LUXMAN B12

MODEL

SERVICE MANUAL

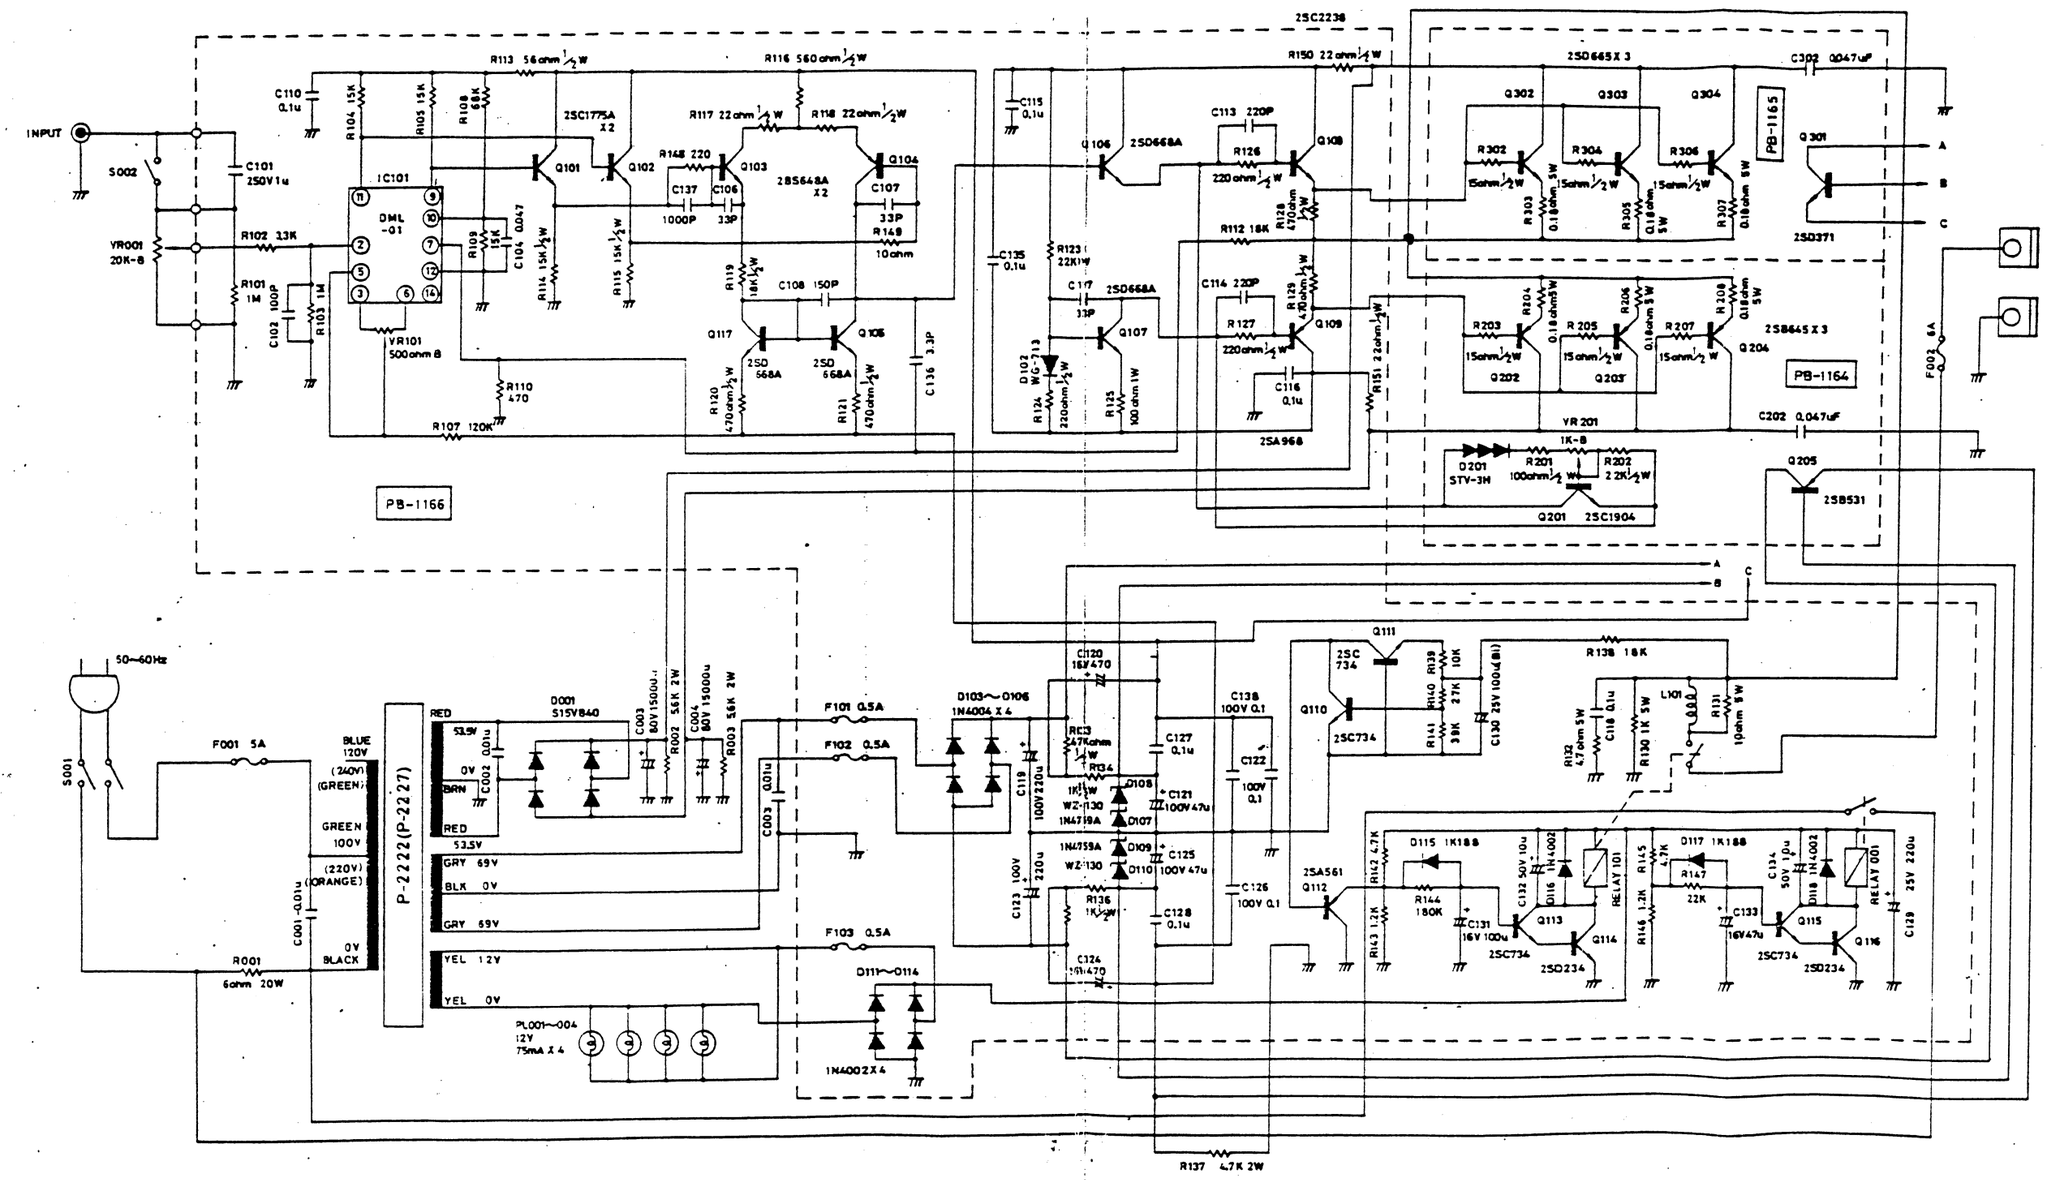
nach DML tausch.
DC offset nicht auf 0V einstellbar
Punkt 3 und 4 des DML verbinden
